<b>ITEM: 6.4</b>	<b>REPORT SUMMARY MINOR VARIANCE APPLICATION FILE NUMBER A132/24</b>
------------------	--

## MINOR VARIANCE APPLICATION FILE NUMBER A132/24

<b>CITY WARD #:</b>	2
<b>APPLICANT:</b>	Abbasali Murteza Hassanali & Ruqayyah Gulamhussein
<b>AGENT:</b>	Imtiaz Alibhai & Salma Alibhai (SPDG INC.)
<b>PROPERTY:</b>	8336 Pine Valley Drive, Vaughan
<b>ZONING DESIGNATION:</b>	See below.
<b>VAUGHAN OFFICIAL PLAN (2010) DESIGNATION:</b>	Vaughan Official Plan 2010 ('VOP 2010'): "Low-Rise Residential"
<b>RELATED DEVELOPMENT APPLICATIONS:</b>	N/A
<b>PURPOSE OF APPLICATION:</b>	Relief from the Zoning By-law is being requested to permit a proposed sunroom in the rear yard.

# Site Plan

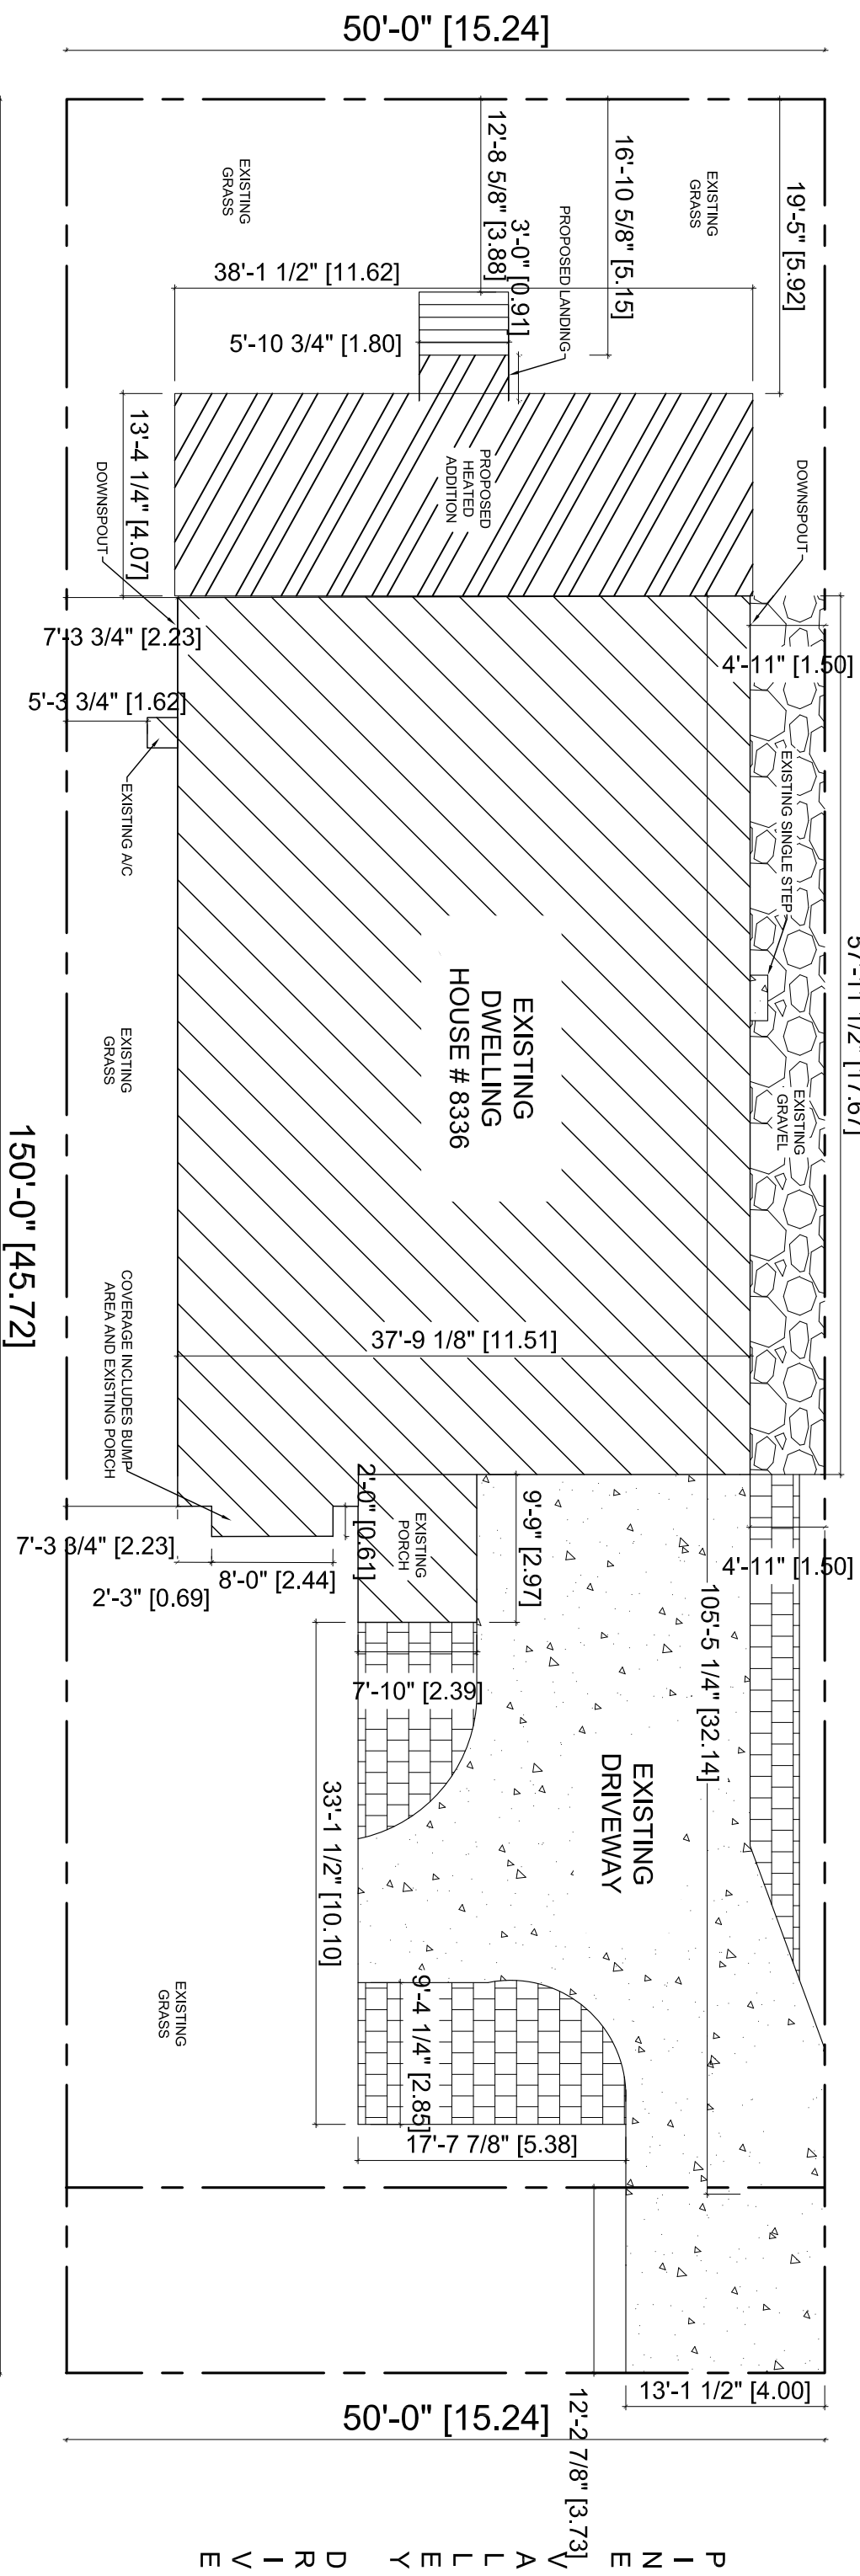
The Development Planning Department has no objection to Variance 1 to allow a 5.92 m rear yard. The single-storey addition is 4.36 m in height, and spans the entire width of the existing dwelling. The remaining rear yard, which is entirely sodded, is adequately sized to accommodate a variety of recreational amenity functions. Development Engineering staff have reviewed the proposed addition and do not have concerns with the stormwater retention and drainage functions of the rear yard.

The Development Planning Department has no objection to Variance 2 for a maximum lot coverage of 40.56% to permit the proposed addition, which exceeds the by-law requirement by 0.56%. The proposed coverage consists of the existing dwelling (33.3%) and the proposed addition (7.2%). The 0.56% lot coverage exceedance is approximately 3.4 m<sup>2</sup> in floor area, and is not anticipated to be visibly perceptible or anticipated to have a negative impact on the property or the surrounding neighbouring properties. A variety of vegetation exists in and around the rear yard including hedges along the south and north side lot lines and several mature deciduous and coniferous trees to the east, northeast, and southeast of the rear yard. The existing vegetation is anticipated to provide adequate visual buffering between the addition and the neighbours to the north (8340 Pine Valley Drive) and south (21 Hayhoe Avenue), as well as the public realm along Hayhoe Avenue to the west, which is in close proximity to the rear lot line. The proposed addition has a modest mass that complies with height and interior side yard setback provisions, and is appropriately screened from impacted neighbours. Urban Design staff anticipates that the construction of the proposed addition may potentially impact the existing trees in and around the rear yard, and requests that an arborist letter and tree protection plan be received and approved as a condition of approval.

1. That an Arborist Report and Tree Protection Plan be prepared and approved to the satisfaction of the Development Planning Department.
